Flood Control Project Maintenance
Levee Inspections

Spring 2017 Levee Inspection Results

Reclamation District No. 0108 River Farms

Levee Inspection Report By Mile - Spring 2017

Photo 3 of 3 : UCIP_SP_2017_39707_71680.jpg

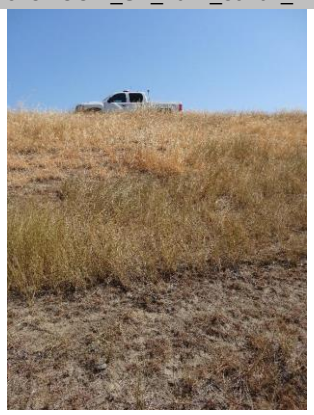
FS_ID:39707
DS_ID:24875
EP_NO: N/A
Repair Type: Non-Urgent
Crossing Status: Indicator Found
UCIP Comments: No signs of pipe visible--need to contact owner to obtain permit number authorizing work. If crossing is no longer used by owner, the owner will need to coordinate with DWR Inspector and CVFPB to remove crossing according to Title 23 requirements. Dense vegetation limits the inspector's visibility to identify signs of pipe failure (leaks) along the slope. Recommend removing vegetation along pipe alignment to conduct proper inspection of structure.
FIELD_STRUCT_DESC: Corrugated Metal (CM) pipe riser located on waterward side. Riser is filled with trash and deris. Unable to determine if crossing exists at this location.
FS Date: 3/18/2014

CMP riser located on waterward toe--2/3 filled with soil and trash.

View of waterward slope.

Photo 2 of 3 : UCIP_SP_2017_37623_68245.jpg

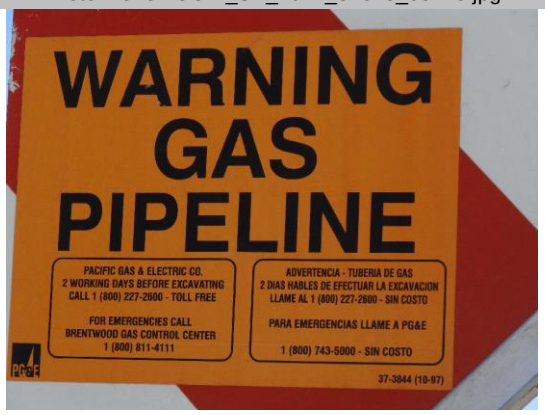
FS_ID:37623
DS_ID:17942
EP_NO: 3800
Repair Type: Non-Urgent
Crossing Status: Indicator Found
UCIP Comments: Need to contact owner--marker missing on waterward side.
FIELD_STRUCT_DESC: 20-inch concrete encased gas line through levee, 3.0 feet below the crown. Crossing appears to be angled through levee (App. 3800-PG&E) Small rock revetment on the waterward slope. (unable to locate) Gas well approximately 1,000 feet from landward toe.
FS Date: 6/10/2014

Contact information for gas line going through levee.
